# ACPE IWG #10

## ■ Pedestrian operation area proposal

### 5.1.5. (d)

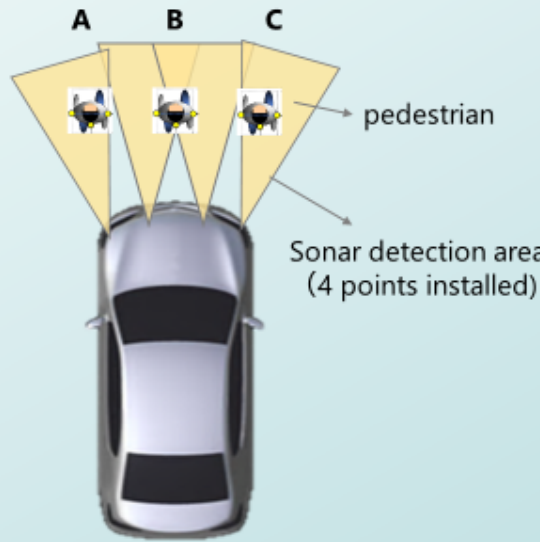
■ **Detection of Sonar sensor**

- Sonar sensor does not have lateral resolution.
- Using two sonar sensors data, system decide it's position.
- To avoid false positive, with sonar, objects detected by two sensors are determined to be targets. (Ensuring detection reliability)
- Regarding objects located at the edge of the vehicle, such as A and C, detection reliability cannot be ensured with just one sensor, and it is not possible to determine whether the object should be activated.

● We can't distinguish between A and A' by one sonar detection data.

### ■ Pedestrian detection at the edge of the vehicle

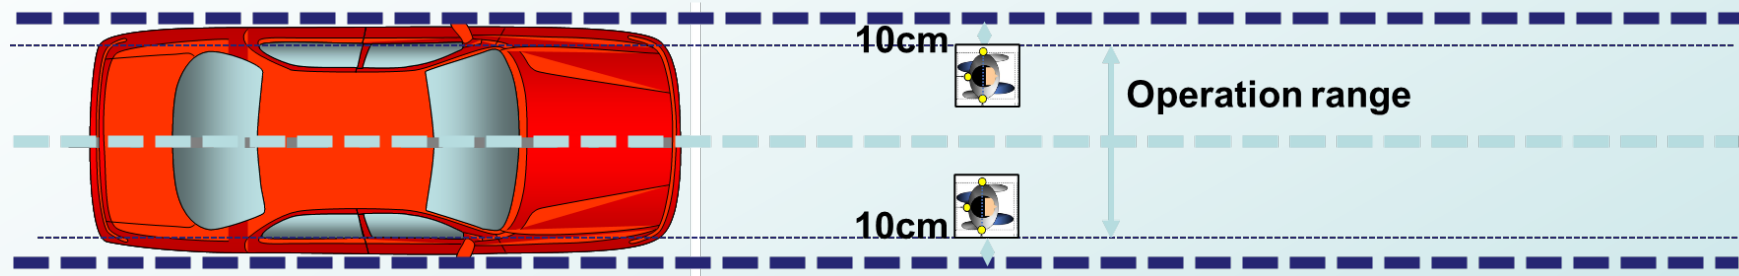
- Target ; Child pedestrian → Short height
- Detection distance :  
Detection is required up to short distances  
→ Only the upper chest area can be detected  
→ Need to improve short-distance recognition performance
- Detection at the edge of the vehicle :  
**Image distortion** is affected at the edges of the camera's field of view.  
→ Robust detection is difficult

To robust ACPE control, it is required robust obstacle detection technology that works in conjunction with ultrasonic sonar sensor information, etc.

### ■ Operation area proposal

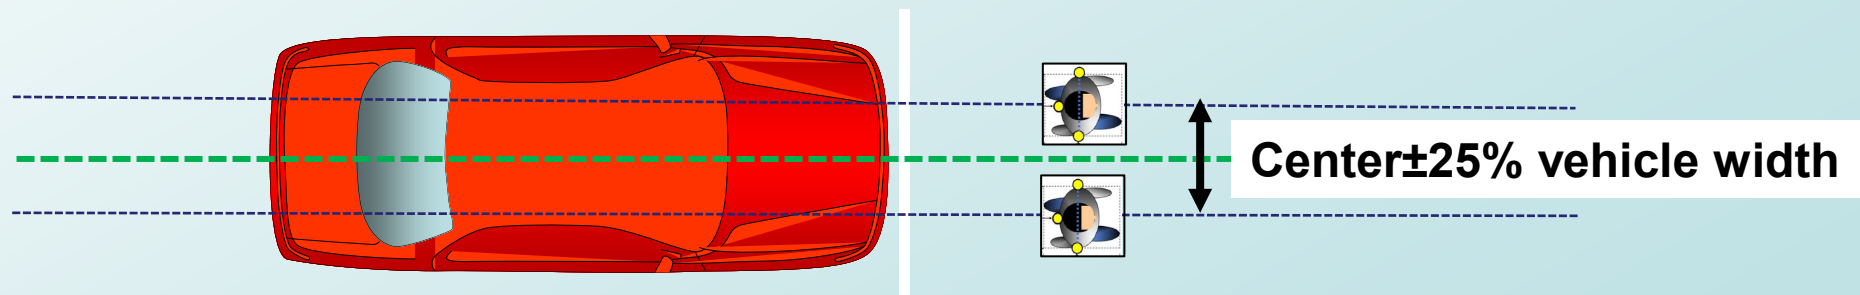
Considering the robustness of ACPE pedestrian operation, propose a vehicle center  $\pm 25\%$  range.

- (iii) In the case of a pedestrian obstacle, the lateral offset between subject vehicle centreline and pedestrian centreline shall be 0.0 m and **25% of the subject vehicle width**.
